Re: Approval of Application to Permit a Portion of Lease UTU-74804, Lodestar Energy Inc.,
Horizon Mine C/007/020-SR00B, Outgoing File

**UTAH DIVISION OF OIL, GAS AND MINING
STATE DECISION DOCUMENT AND
TECHNICAL ANALYSIS**

Lodestar Energy Inc.
HORIZON MINE
C/007/020
Carbon County, Utah
February 26, 2001

Figure 5 Cumulative Hydrologic Impact Assessment Horizon Mine
MINE MAP Haiwatha Seam(Wattis)
File: minemapwattis.gra
Compiled by: Dan Smith Date: February 27, 2001

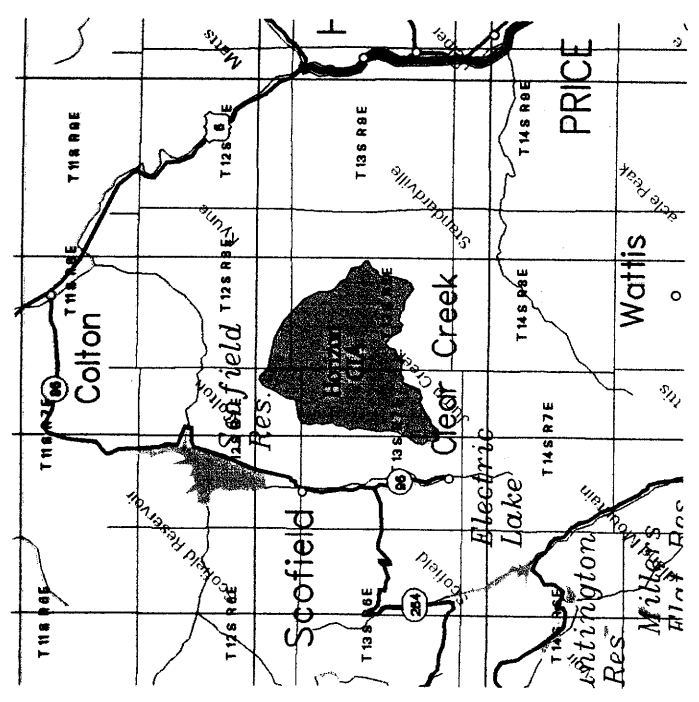
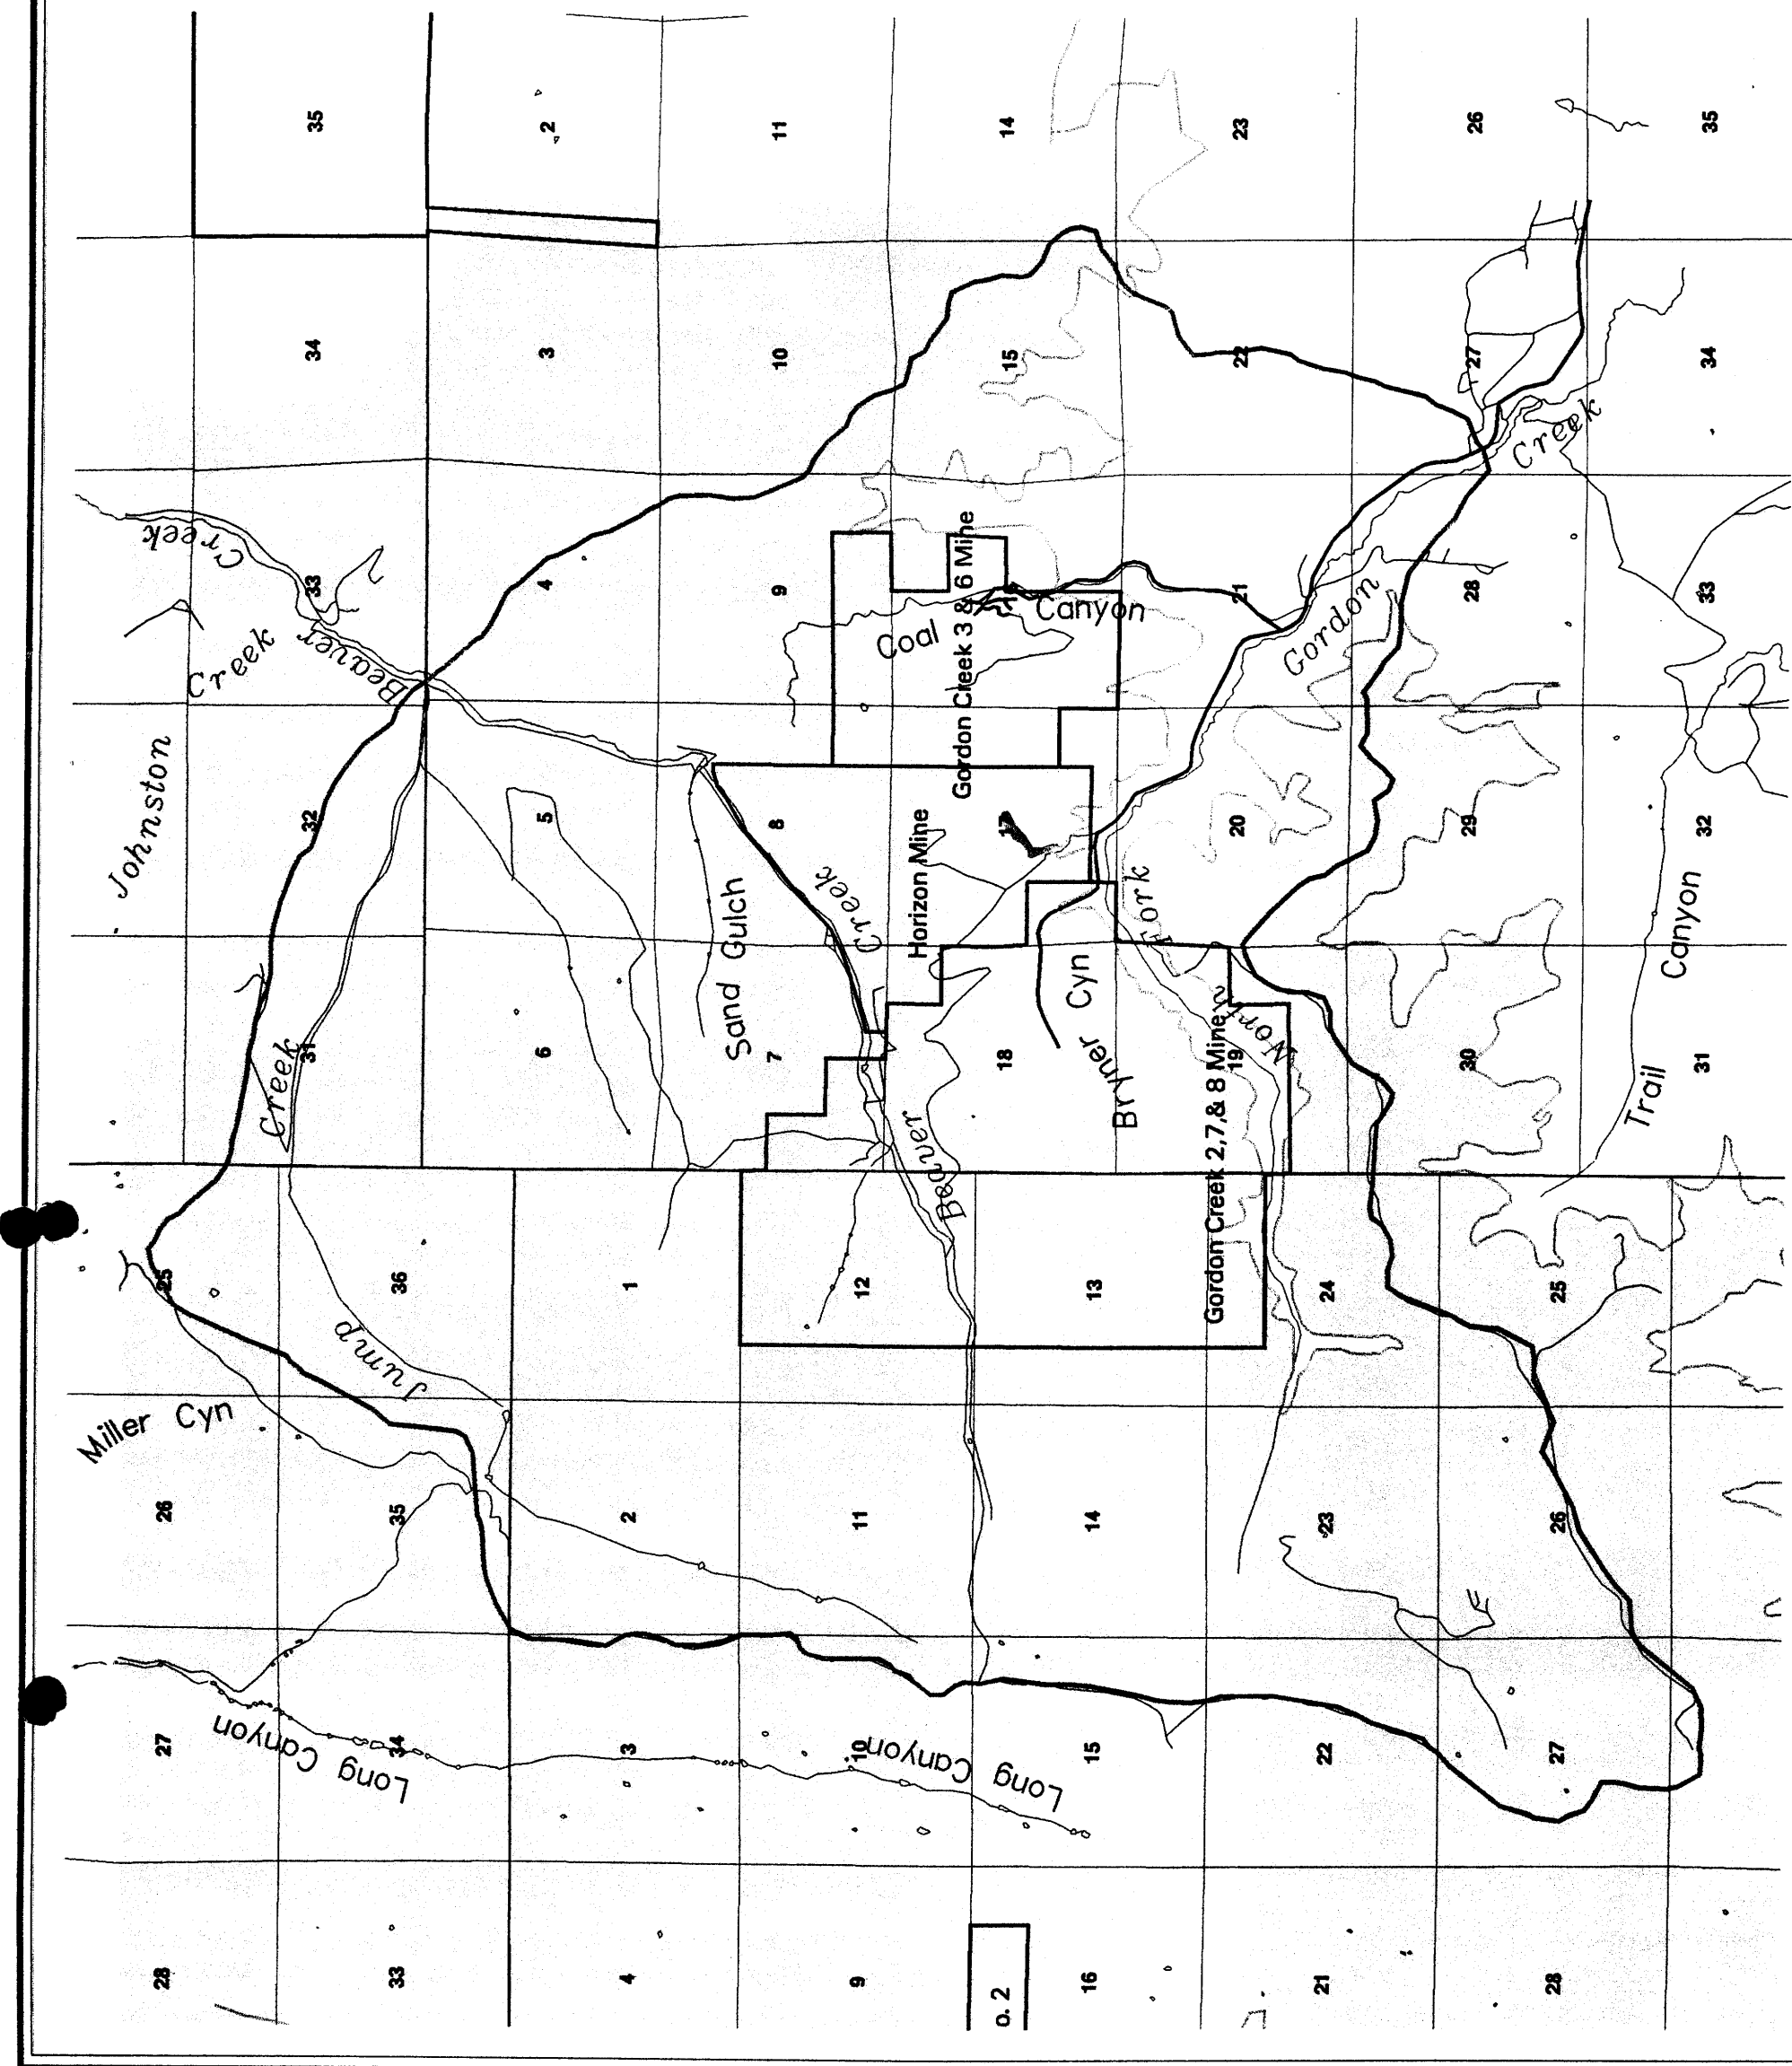
There are two coal seams of economic interest at present, **Figures 4 and 5**. These seams are the Castlegate A Seam, **Figure 4**, which lies above the Aberdeen Sandstone Member of the Blackhawk Formation and the Hiawatha Seam (Wattis, after Tabot 1999), **Figure 5**, sits directly on the Starpoint Sandstone. Recent, geologic evaluation of the coal seams by personnel of the Utah Geological Survey presents an updated nomenclature of the coal seams in the northern Wasatch Plateau.
